CITY OF PORTLAND, MAINE
PLANNING BOARD

Project Name: Sheridan Street Apartments
Address: 152-156 Sheridan Street
Applicant: New Day Farm, LLC

Project ID: 2013-241
CBL: 12 P021001
Planner: Nell Donaldson

To: FILE
From: Nell Donaldson
Subject: Application ID: 2013-241
Date: 1/23/2014

C-4.0 grading plan

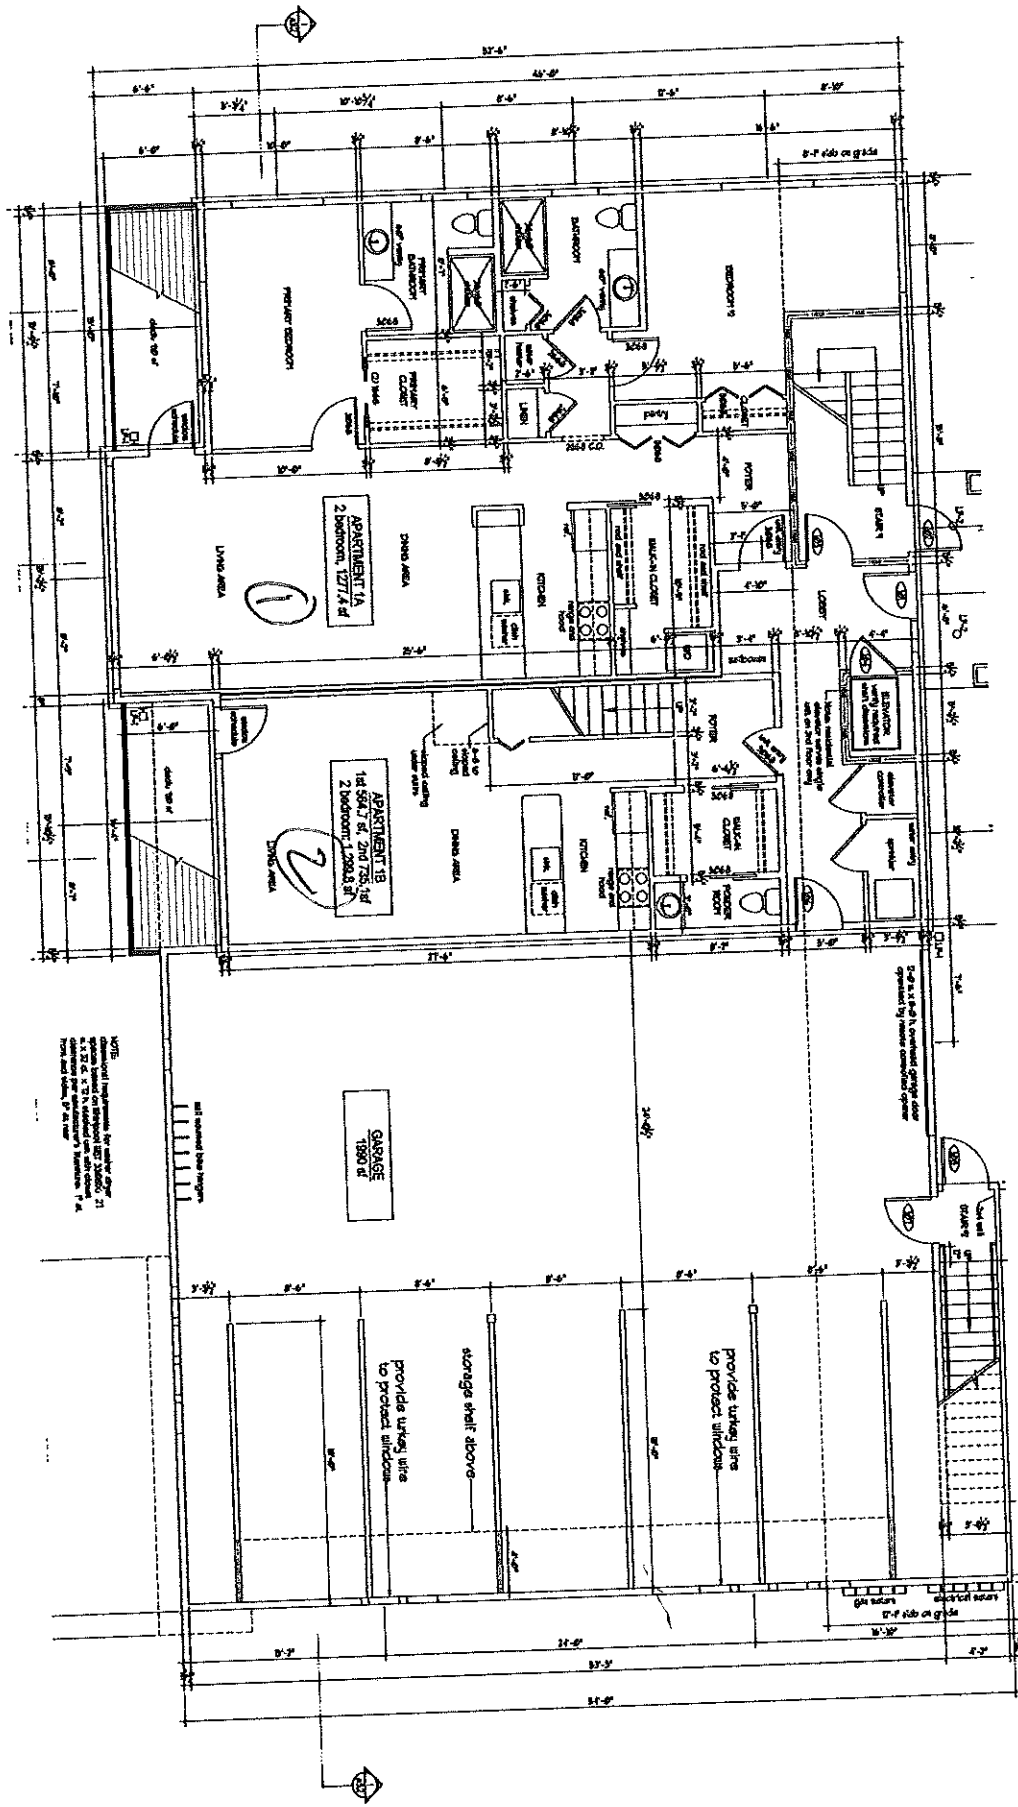
10/23/14
need
at grade

$$\begin{array}{r} 113 \\ 115 \\ 87 \\ \hline 98 \\ 8-13 \div 4 = 103.25 \\ \text{A.V. grade} \end{array}$$

top of sloping
 146' 3 1/2"
 (146.291')

Average grade
 at 4 corners
 of Bldg =
 103.25
 max allowable
 height 45'-
 would be at
 148.75

1 South Elevation
 1/8" = 1'-0"

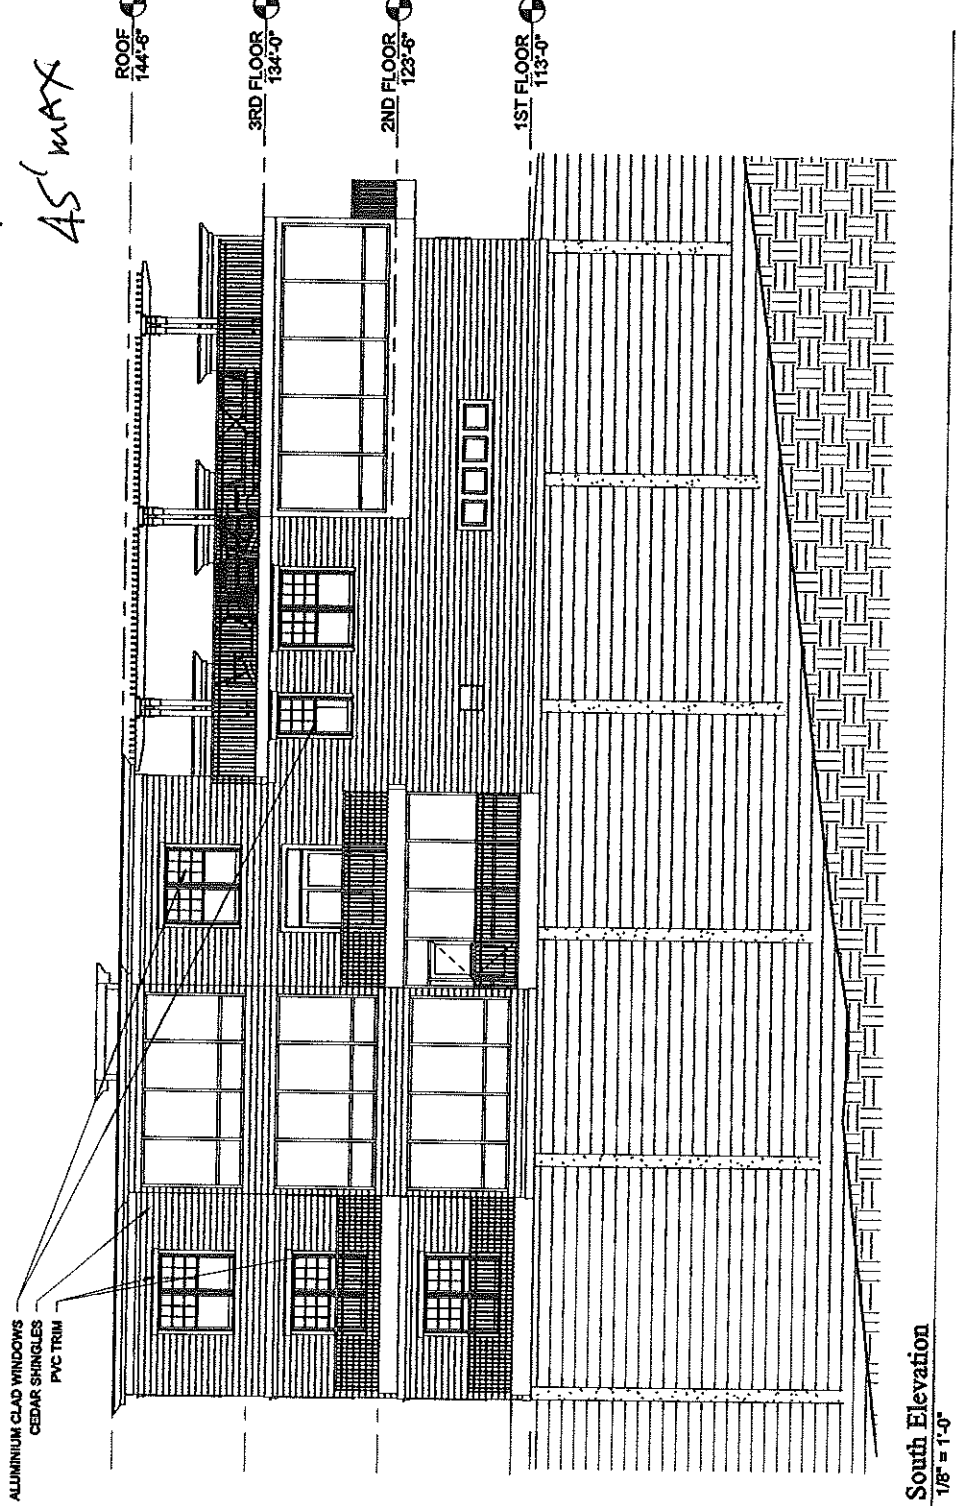
$$\frac{144.5'}{-113.00'} = 3/5 \text{ low front}$$
 45' MAX
